- A. 7-Eleven Gas Station - 1650 W. Algonquin Rd. - PC#18-026
Special Use Permit for Auto Service (Gas) Station, Variation

File Number: PC 18-026
Project Title: 7-11 Gas Station
Address: 1650 W. Algonquin Rd.
PIN: 08-08-401-028

Case Number: PC 18-026

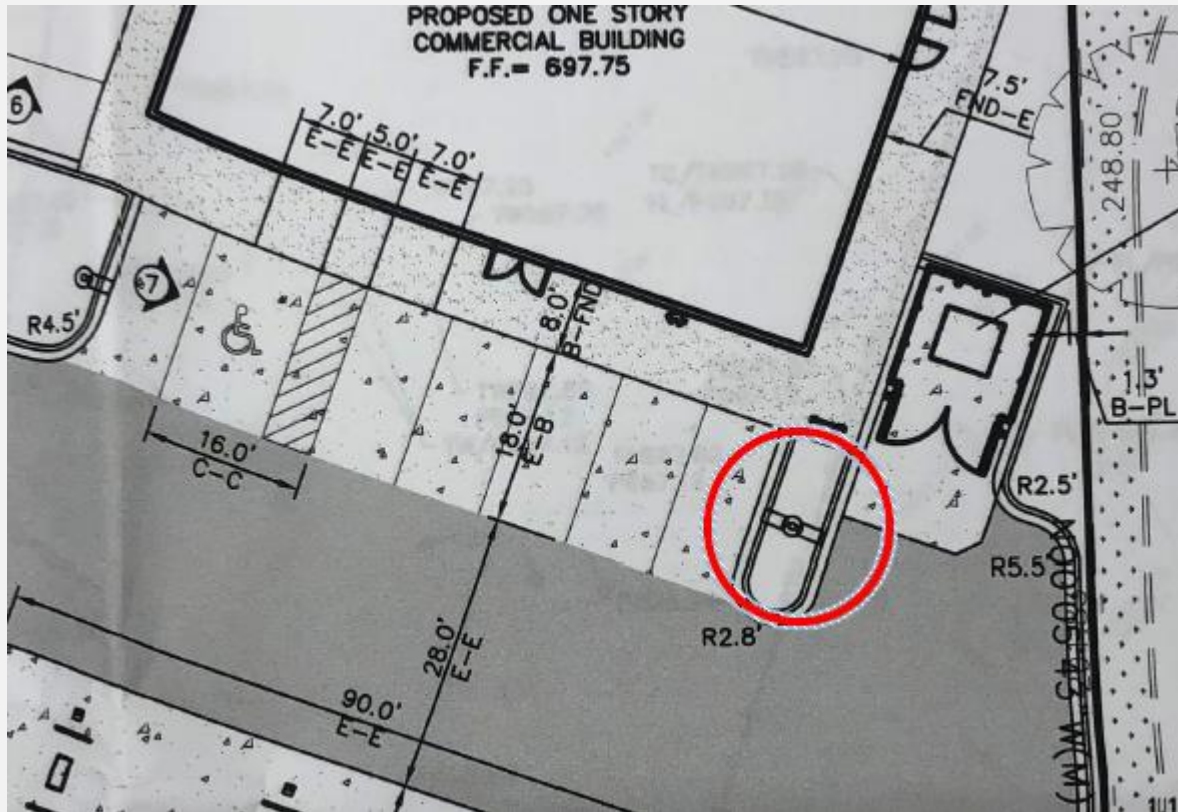
20. Due to concerns from the neighboring residential property owners to the north, combined with the fact that the proposed plan reduces the greenspace/buffer that currently exists at the north of the property, it is recommended that a 6' tall solid fence be provided as indicated below.

REMOVABLE HOOD basin and water
quality structure DETAIL

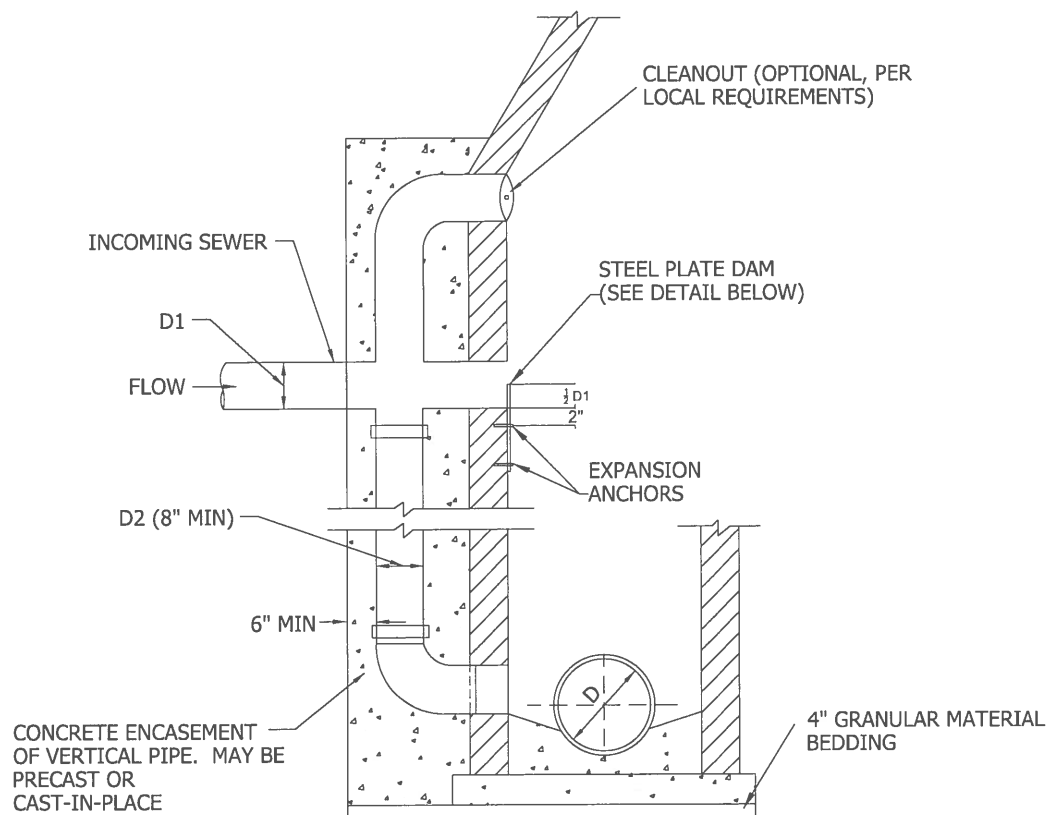
31. The petitioner's response to Comment #14 is noted. Regarding the snout oil-grit separator detail shown on sheet C-3 and the restrictor plate detail provided on sheet C-4, a removable hood should be constructed over the outlet pipe. For reference, enclosed is a removal hood detail from the Metropolitan Water Reclamation District (MWRD). If the restrictor is intended to be installed along with the snout oil grit separator, revise the detail accordingly and confirm that it meets the requirements shown in the MWRD detail. Provide the necessary details for the proposed detention storage system located under the

Response: The detail has been added and modified on sheet C-3. The StormTrap plans have been included in this submittal.
